TRANSMITTAL

Project Description: Replacement Senior Citizen Center Construction

To: Josh Marrillia, Marrillia Design & Construction RE: Change Order #25

CHANGE ORDER NO. 25

SKA-087

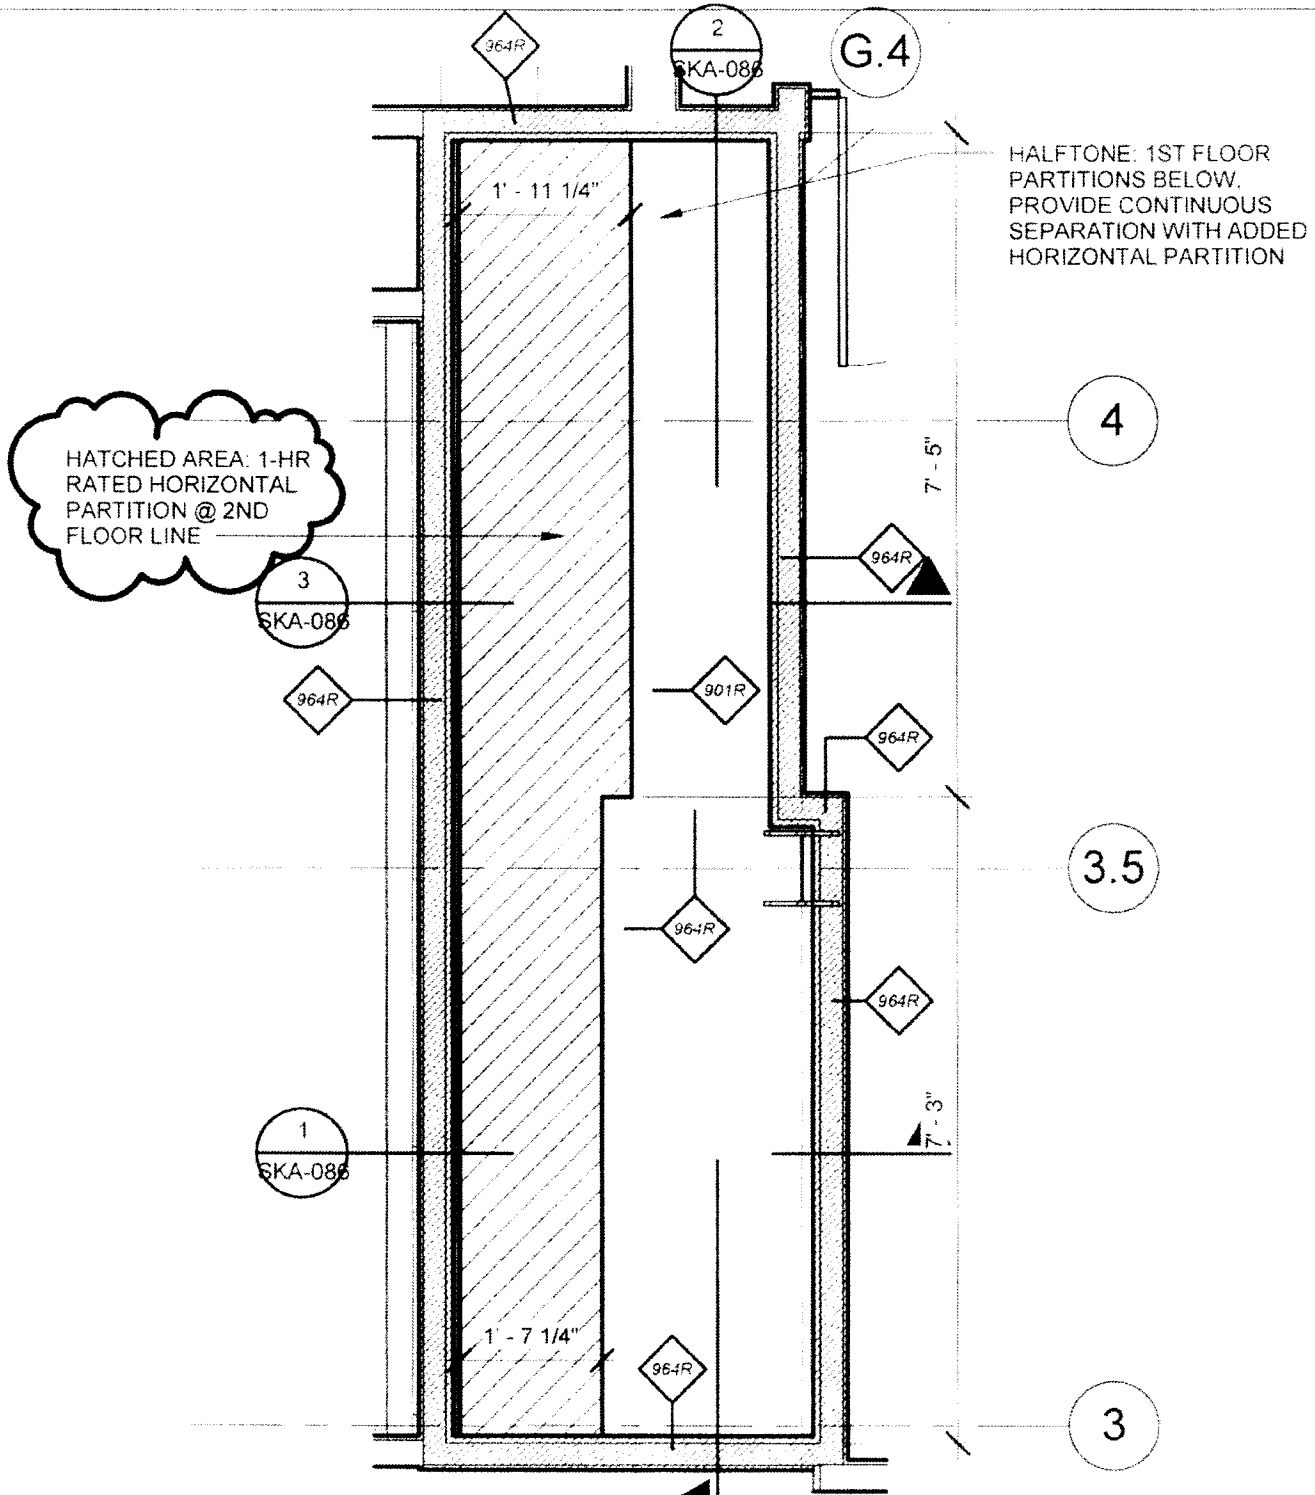
Please see the attached sketches for the addition of a horizontal 1-hr rated partition to complete the rated shaft enclosure.

HATCHED AREA: 1-HR RATED HORIZONTAL PARTITION @ 2ND FLOOR LINE

HALFTONE: 1ST FLOOR PARTITIONS BELOW. PROVIDE CONTINUOUS SEPARATION WITH ADDED HORIZONTAL PARTITION

During design, we provided a mechanical chase for HVAC ductwork to move between floors. The size of the chase was different on each floor. When we created the openings in the slab, we used the larger, 2nd floor chase to determine the opening. This decision left some 1st floor chase walls without a top enclosure. The solution proposed is to build a horizontal partition (essentially, a ceiling with GWB on both sides at the floor line) to provide that top enclosure and retain a continuous 1-hour rated enclosure for the chase.

SKA-091

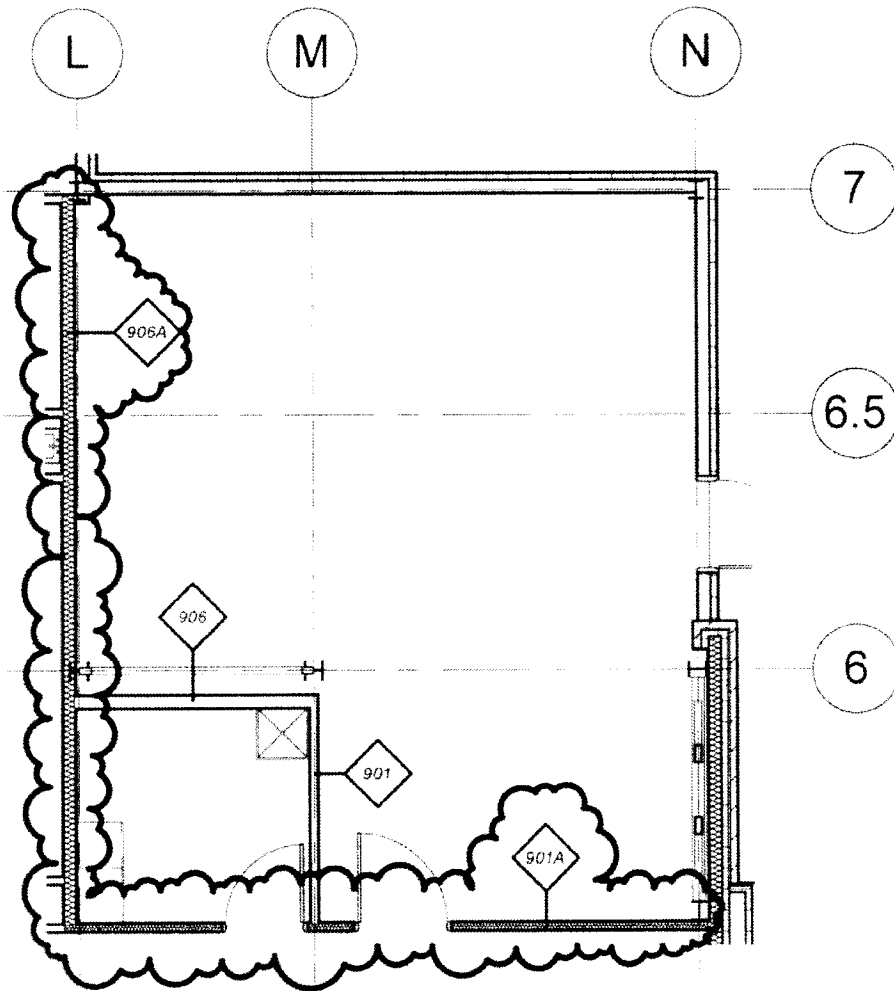
Please provide pricing to extend framing and gypsum board drywall to the deck, and to add acoustic batt insulation within the wall cavity, at the partitions shown in the attached sketch. Partition framing depth and module of framing members shall remain as originally designed. Penetrations in partitions shall be acoustically sealed. Please provide the following details for pricing:

Please find the attached pricing to extend the mechanical room partitions to the deck. The price shifted upward from our last discussion due to an allowance (which may not be entirely used, in which case it would be credited) for acoustical sealing of mechanical and electrical penetrations, a reasonable expectation. I find the time extension, when you consider the additional drywall work, to be appropriate. Please let me know if you have any questions about the proposal.
